ADDENDUM NO. 03

PROJECT: Ossining Union Free School District
2024 Bond: Phase 1
OHS Locker Room & CTE Addition

CPL PROJECT NO. R24.16761.00

DATE: May 21, 2026

HS
H503

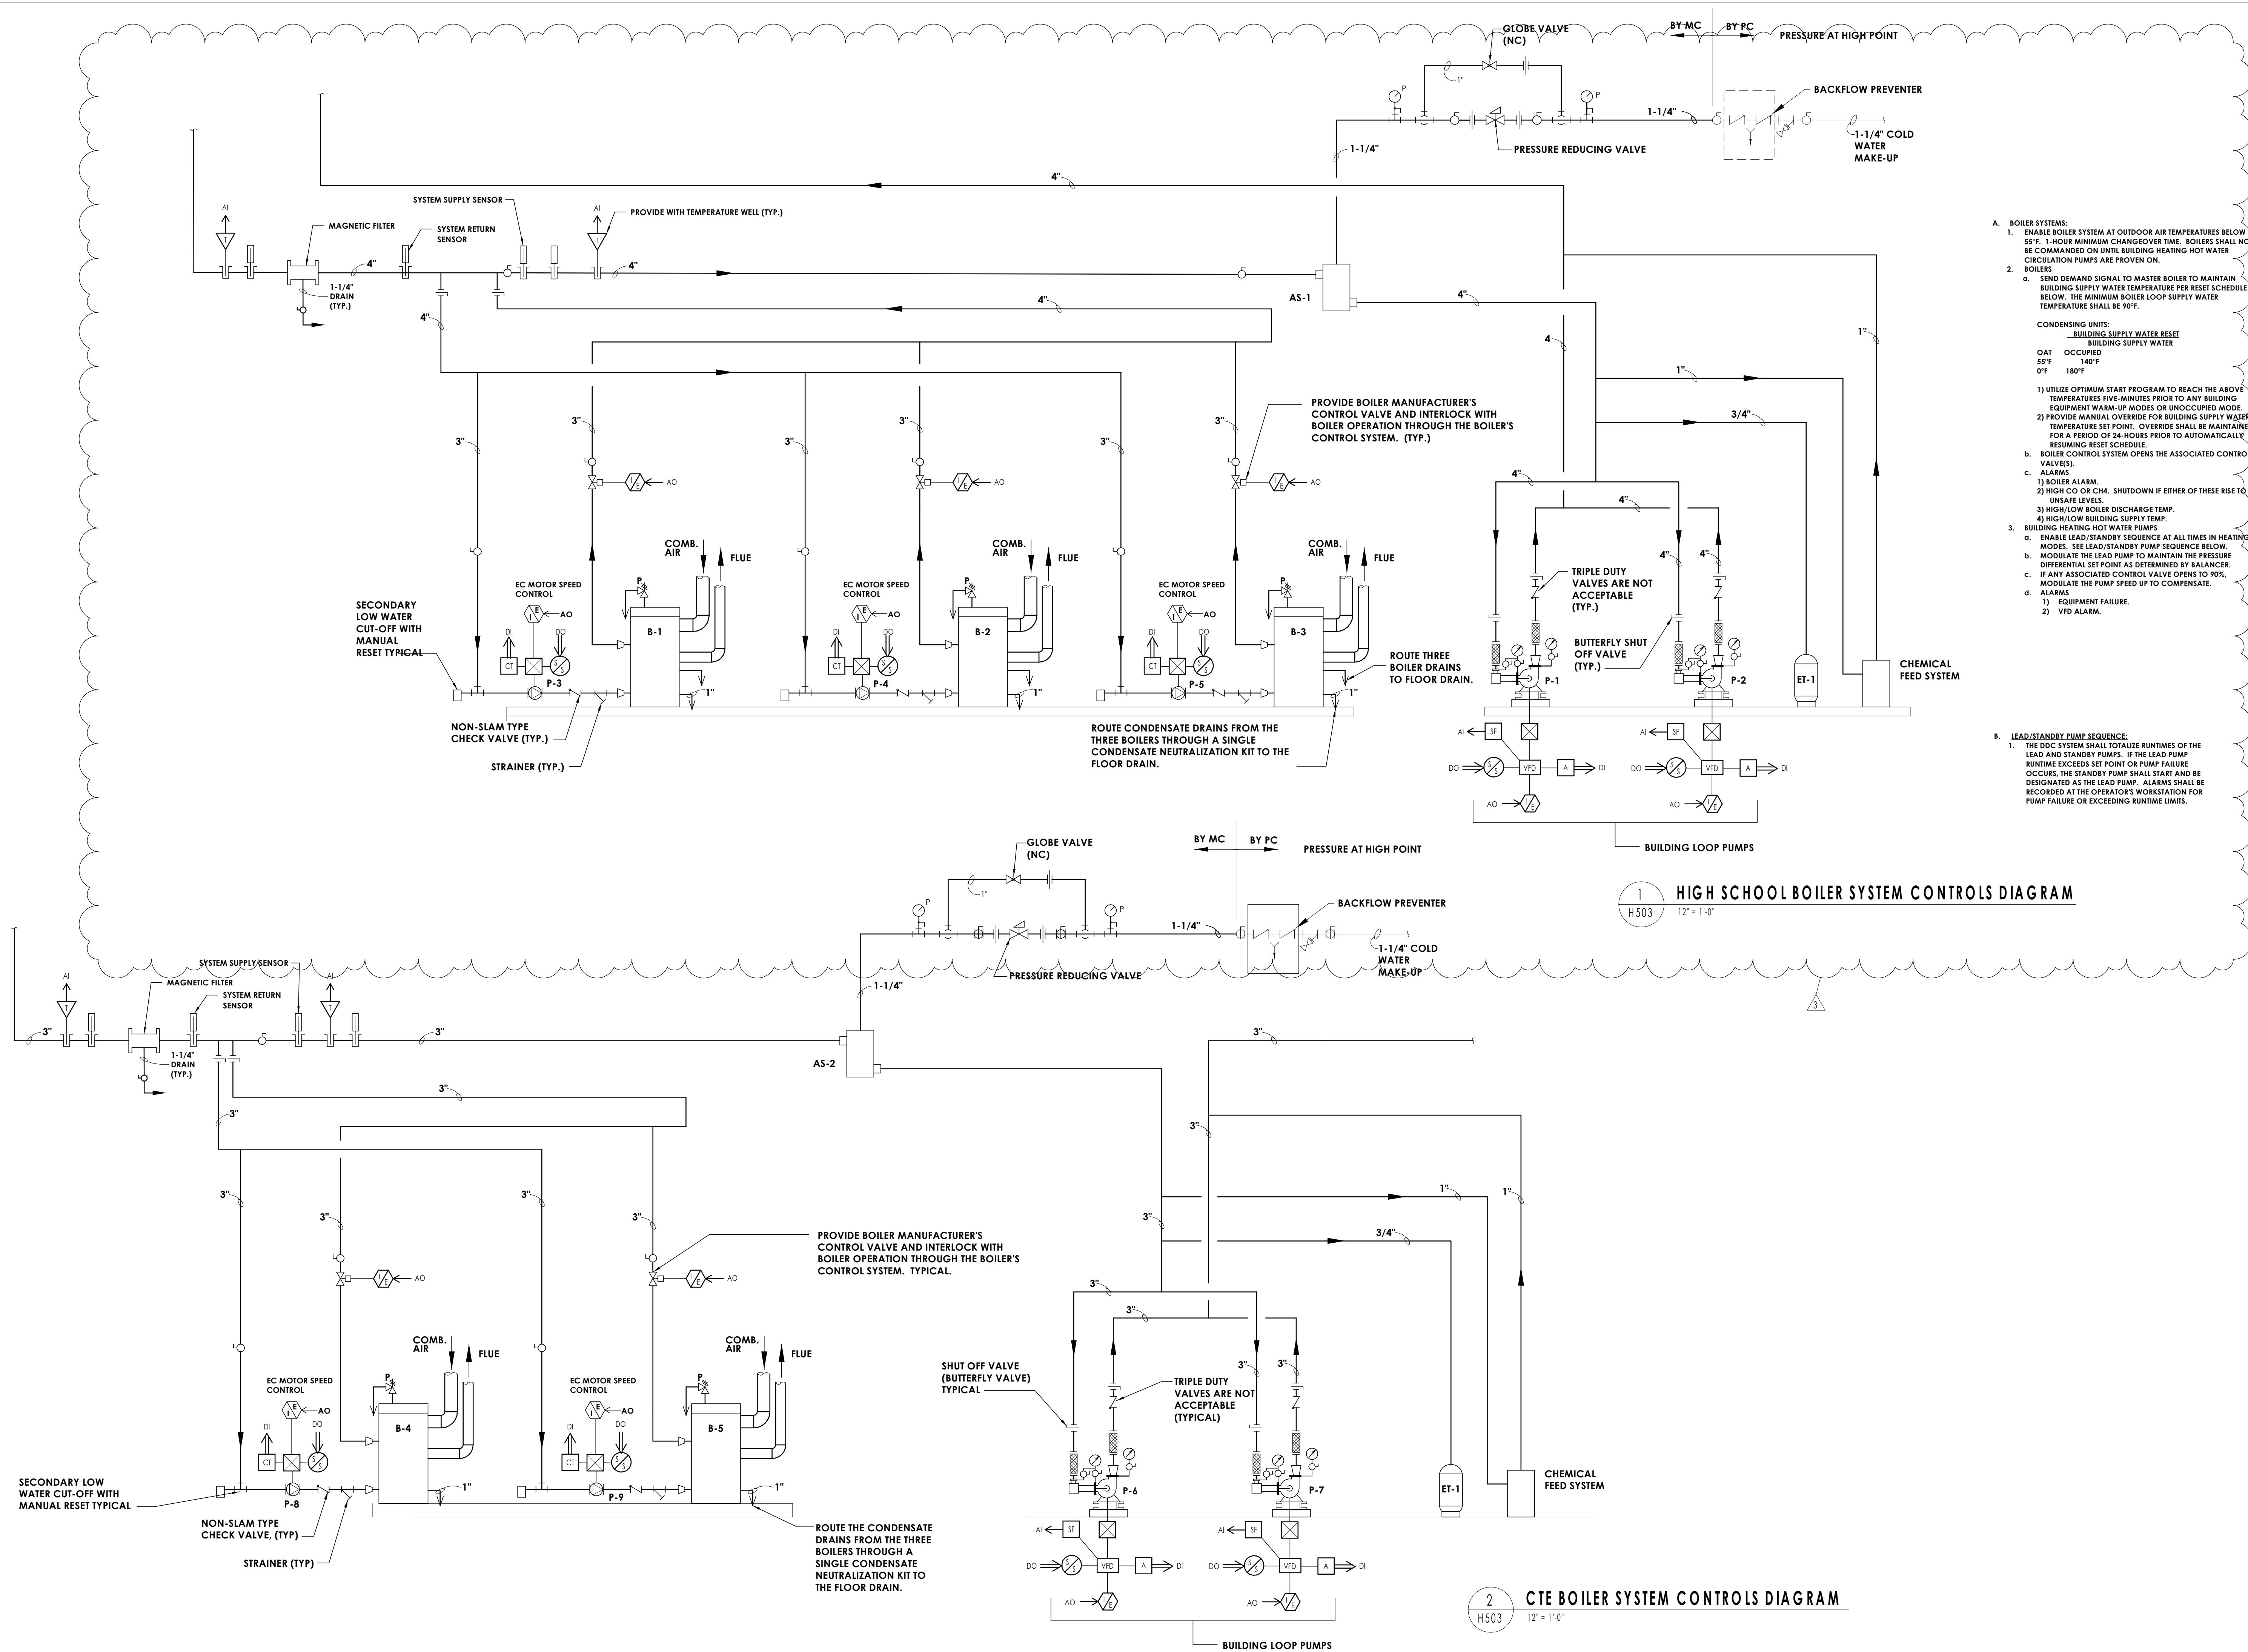
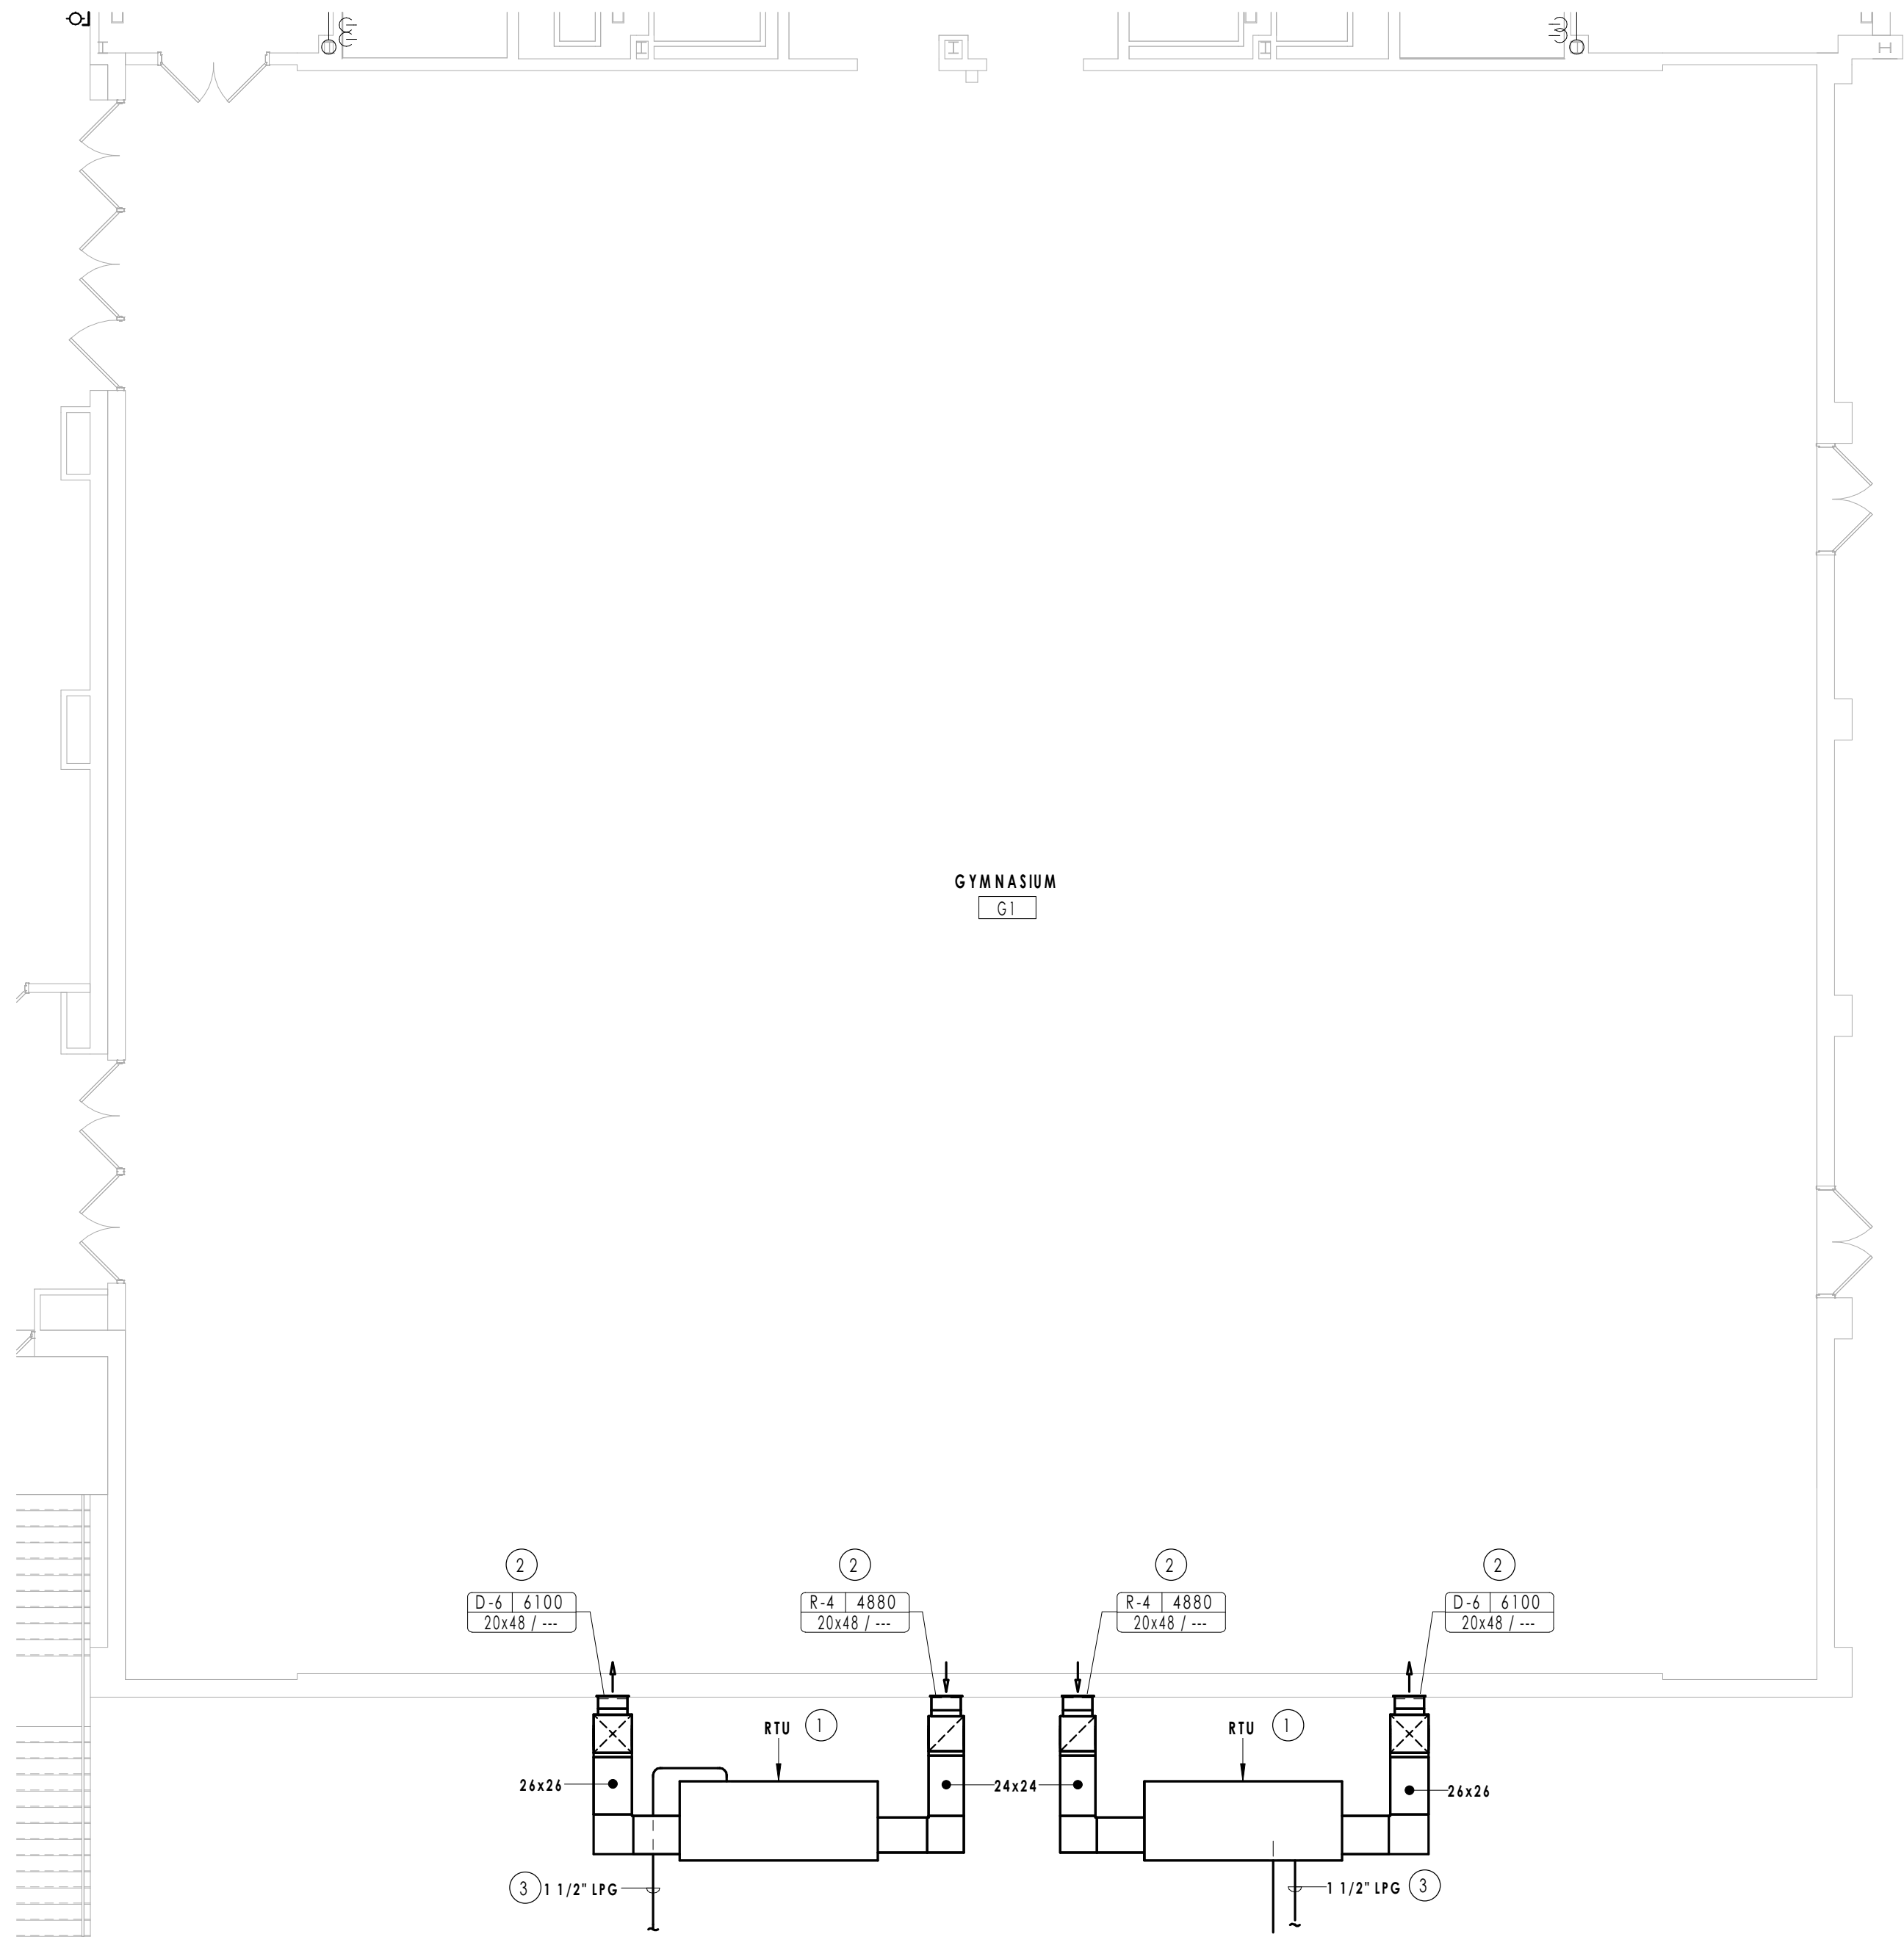
1.25 Question: Please confirm piping size for the main building new boiler room. Drawing H700 shows the primary and boiler loops as 4” while drawing H503 schematic shows these as 3”.

Answer: See revised H503 drawing.
